**Attachments:**

Deemed Provisions – Cl 67 Matters to be considered by local Government

**Figure 7: Bush Forever Area 361 (green), the initially proposed swale (blue) and drainage basin (red)**

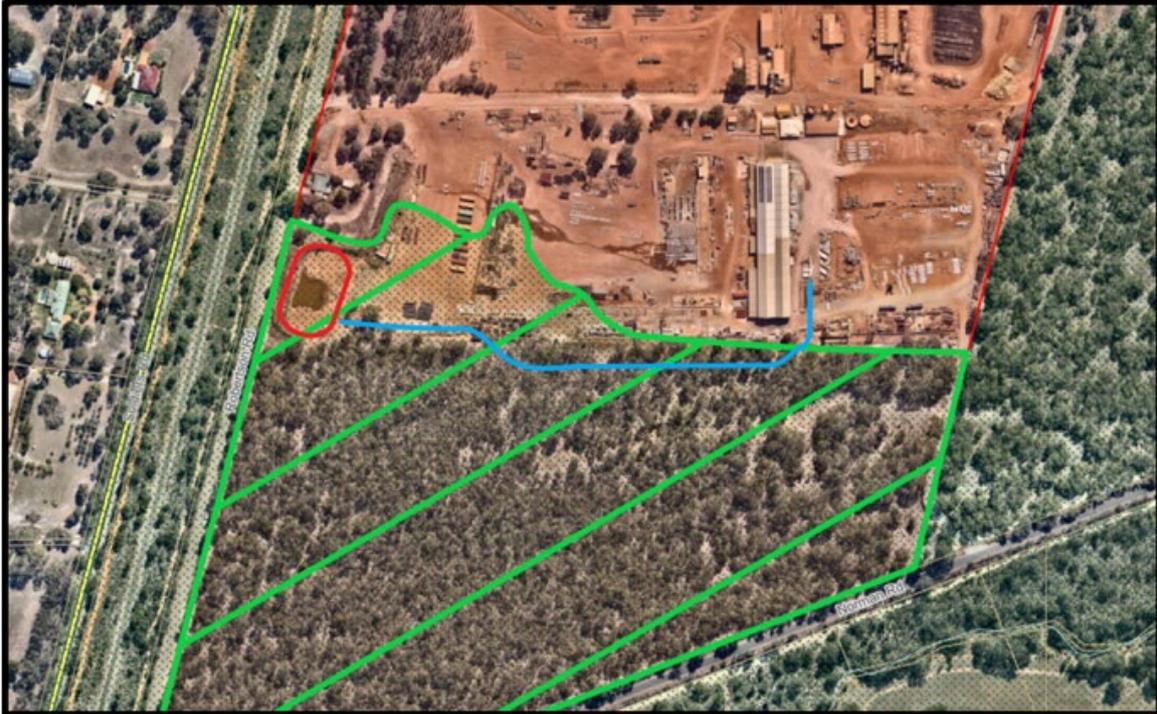
As previously stated, following concerns raised from the DPLH, no part of the application would be located within the vegetated extents of the bush forever site, resulting in the protection of the significant bushland, consistent with SPP2.8. This site is also in the process of being amended to reflect vegetated extents.

**Figure 8: The bushfire prone area (orange overlay) compared to the development area**

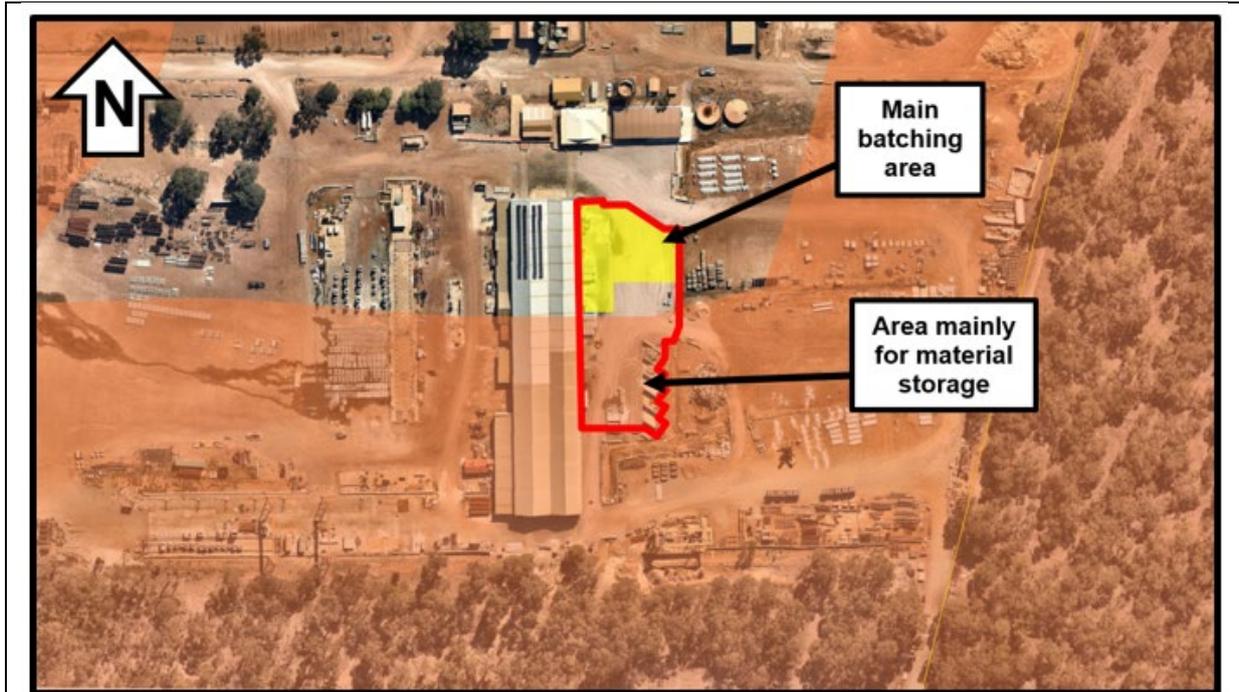
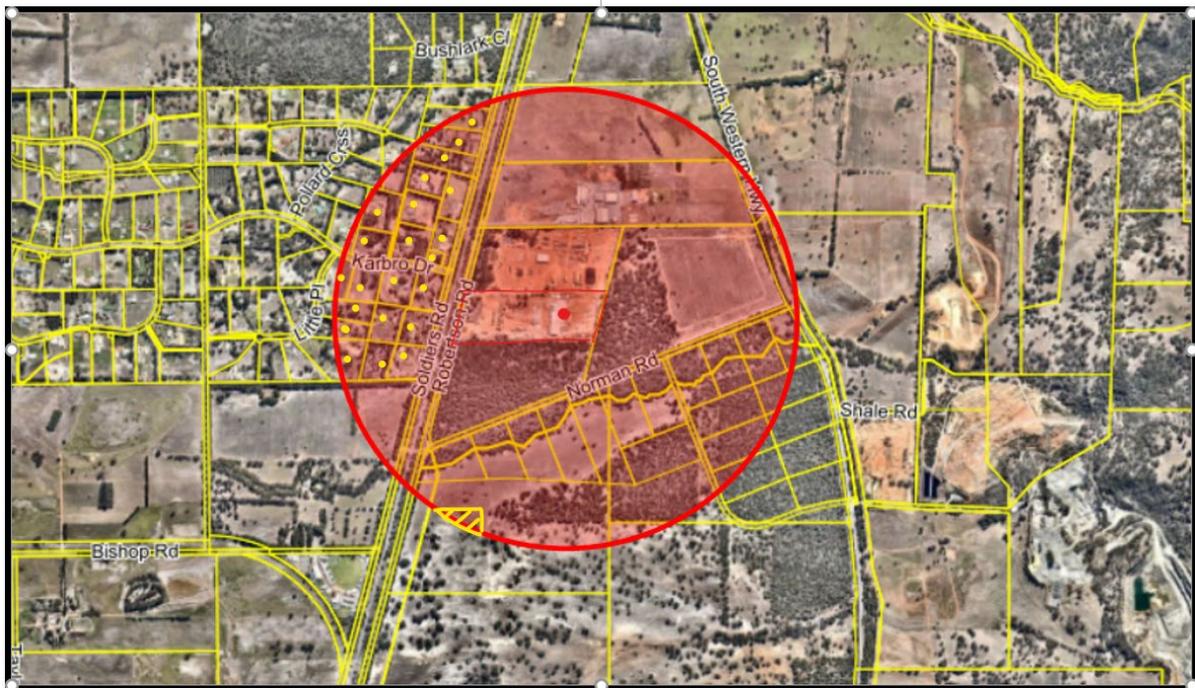
In this instance, the applicant has not provided a BMP as the main concrete batching area would be located outside of the bushfire prone area, as shown on figure 8 below:

While this location is technically outside the BPA, the development area does extend within the BPA. Not having a BMP creates a degree of risk assessment that has not been assessed.

q) the suitability of the land for the development taking into account the possible risk of flooding, tidal inundation, subsidence, landslip, bushfire, soil erosion, land degradation or any other risk	<b>YES</b> <input checked="" type="checkbox"/>	<b>NO</b> <input type="checkbox"/>	<b>N/A</b> <input type="checkbox"/>
<b>Comment:</b> A condition is recommended requiring the submission of a Bushfire Management Plan.
